Plan Commission

Agenda

Monday, April 25, 2016

Item 4: Review and Recommendation on the Site Plan Application for De Pere Café, located at 1104 Honey Court (ED-1469). Applicant: Alliance Construction & Design

SITE AND UTILITY PLAN

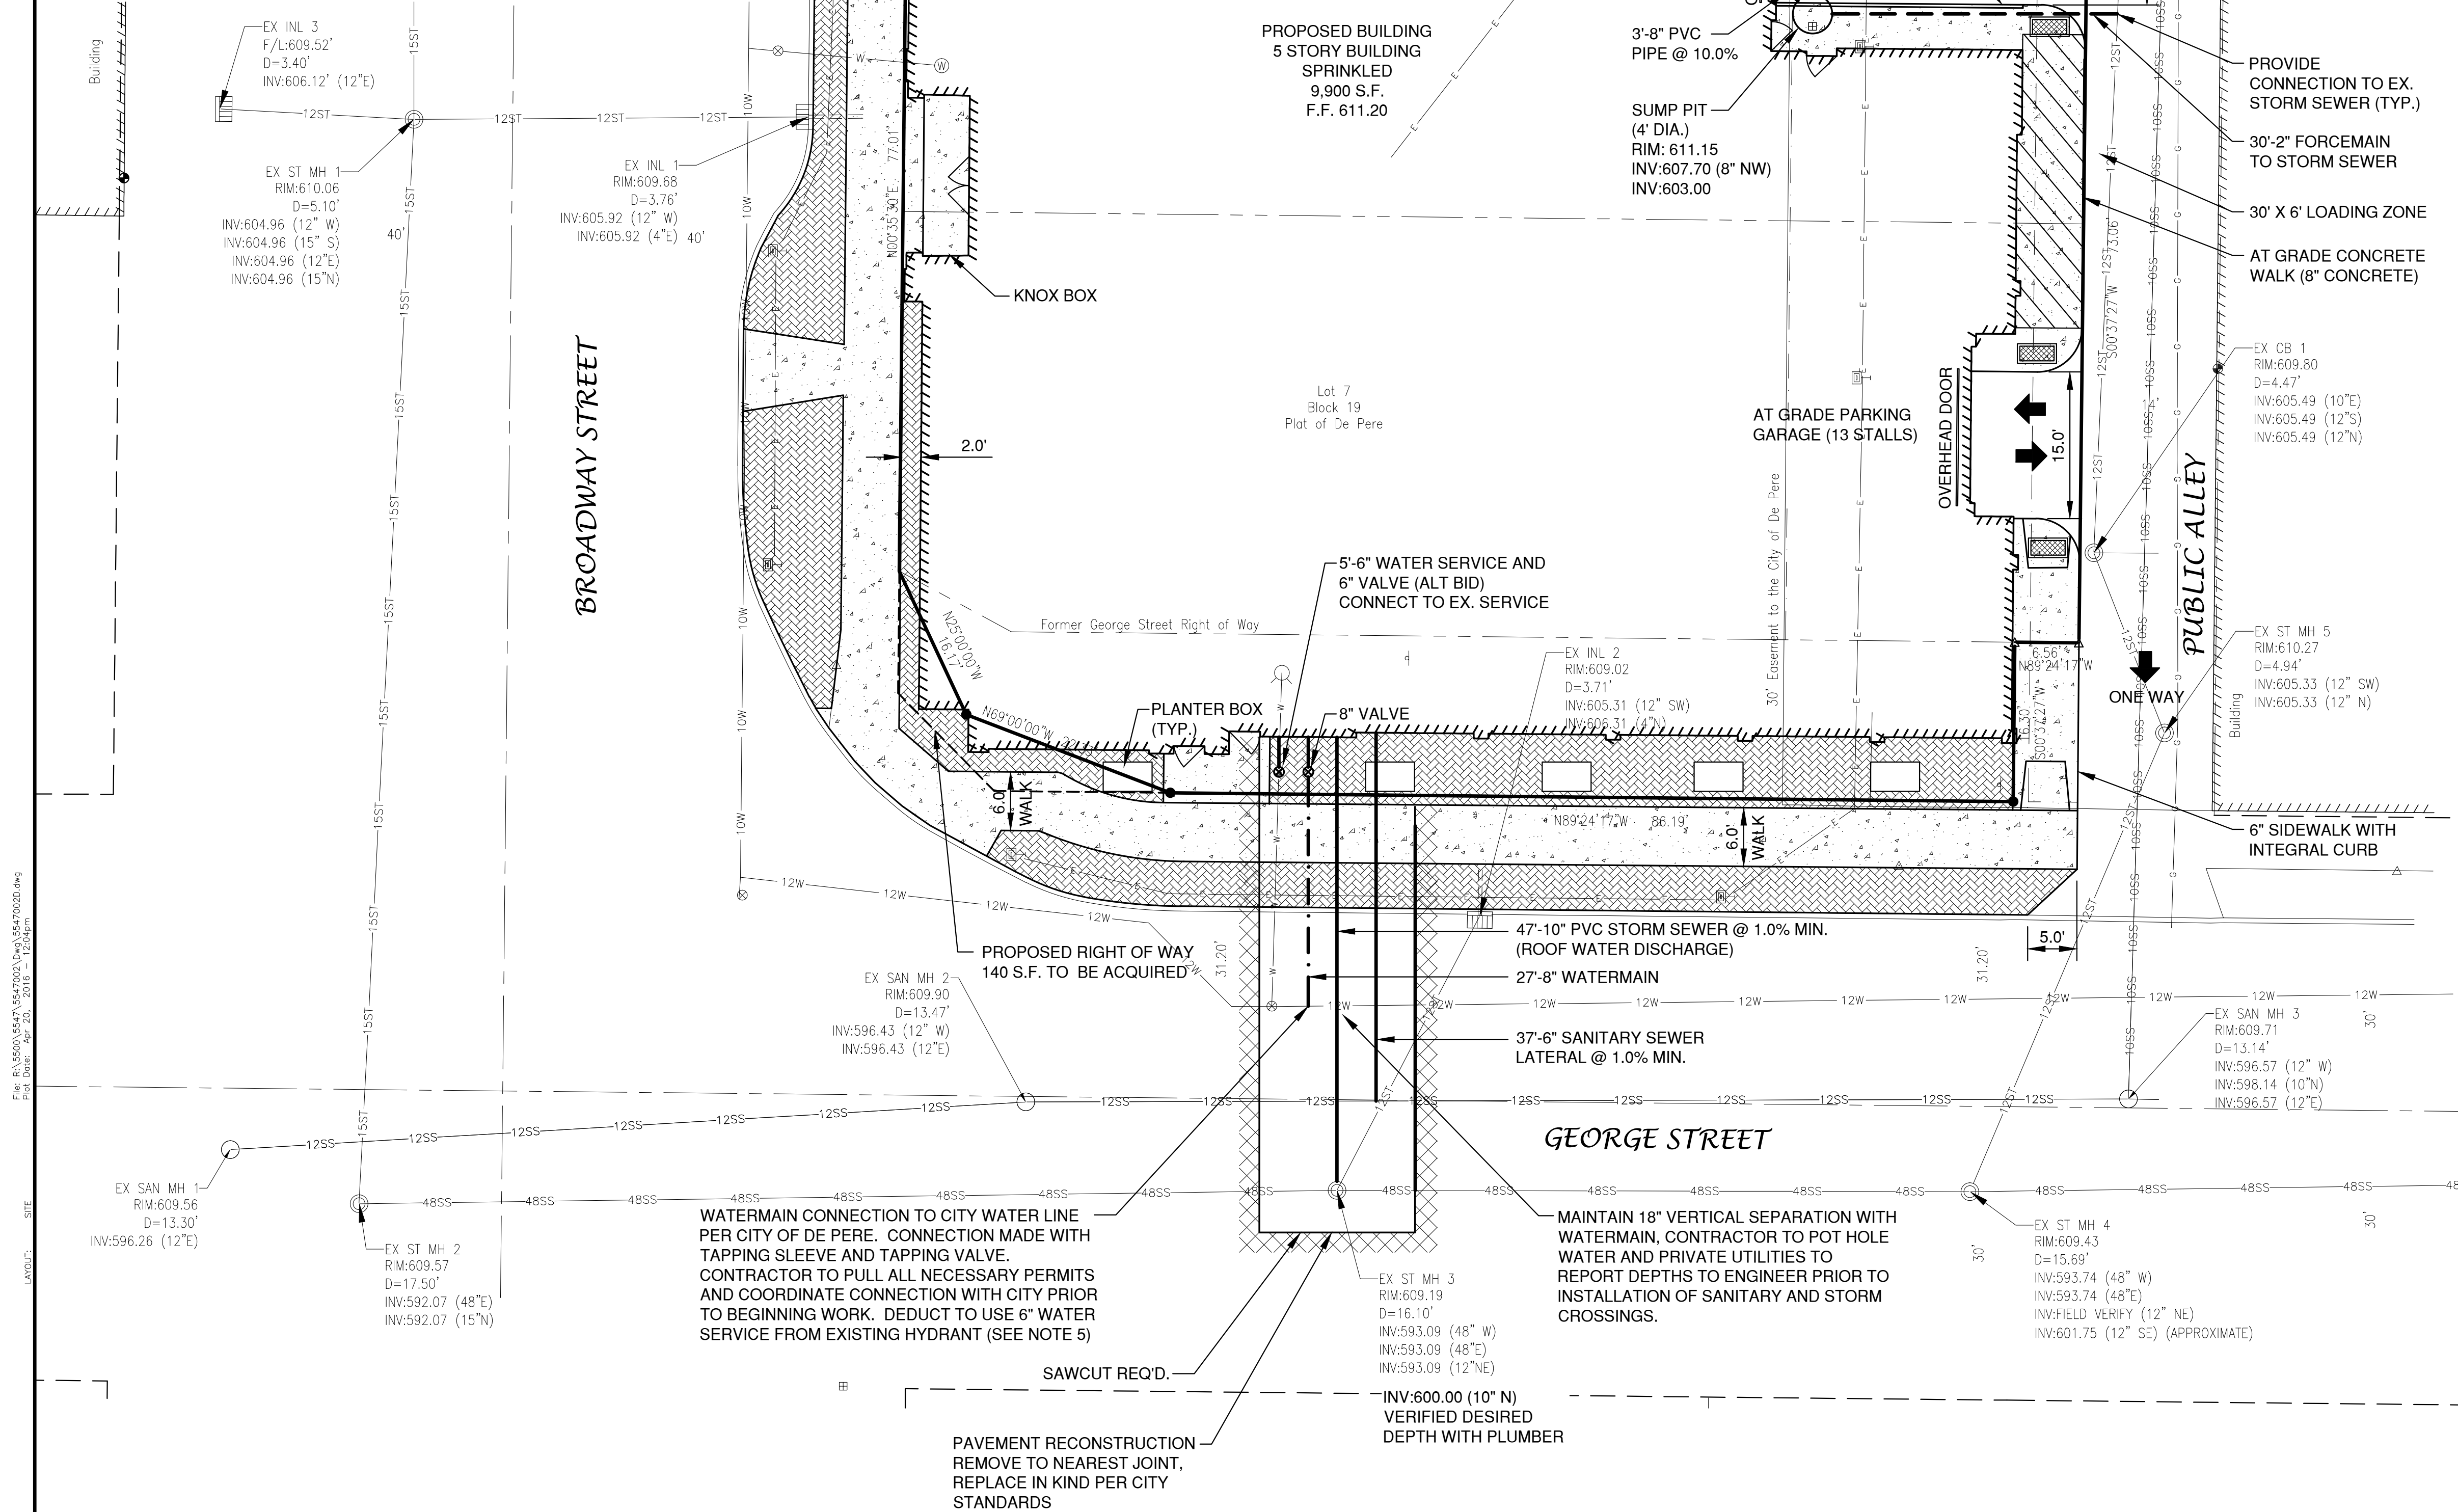
1. List the site address as 102 N. Broadway on the plans.
2. City Street lights along the alley will be removed by the City; the bases and wire will remain. A new street lighting wire will connect from the lighting on George Street along the easement immediately west of the alley to the next light pole north of the site. The street lights on George will be fed by this wire that will be located under the proposed sidewalk. Plans showing the location of the new electrical were provided to Robert E. Lee & Associates on 4/5/16. The existing elevation at the location of the new electrical is assumed to remain the same at the conclusion of construction. Relocation is expected to be complete by the end of April, 2016.

3. Two storm sewer connections are shown on the plan. One connection should be evaluated for maintenance purposes. Provide storm sewer calculations for the site to quantify the runoff to the City storm sewer from this development. The existing storm sewer in the alley has limited capacity. A relay of this pipe may be required or the City may consider a direct connection to the George Street storm sewer. Show the existing utilities on the plan.

6. Lighting calculations provided show exceeding 1 footcandle at the property line on George Street, N Broadway Street, and the alley.
7. Remove the portion of the 30' x 8' loading zone that encroaches into the public alley. This location conflicts with the sidewalk connecting to George Street.

8. Show mailing address of developer/owner and architect on the plan.
9. Water service to the property is shown as 8" connecting to the City 12" water main on George Street. Note on the plan that this connection will be made with a tapping sleeve and tapping valve. Provide documentation that the 8" pipe is needed to serve this development. The hydrant on George Street has been relocated by the City of De Pere. Water meters larger than 1" will require one month advance notice.

13. A 6" sanitary lateral is shown connecting to the City's 12" sanitary sewer on George Street. Show the 12" City sanitary sewer main extending to the east into SAN MH 3 on the plan. Make the connection using Saddle Connection and Wye as recommended by the manufacturer.
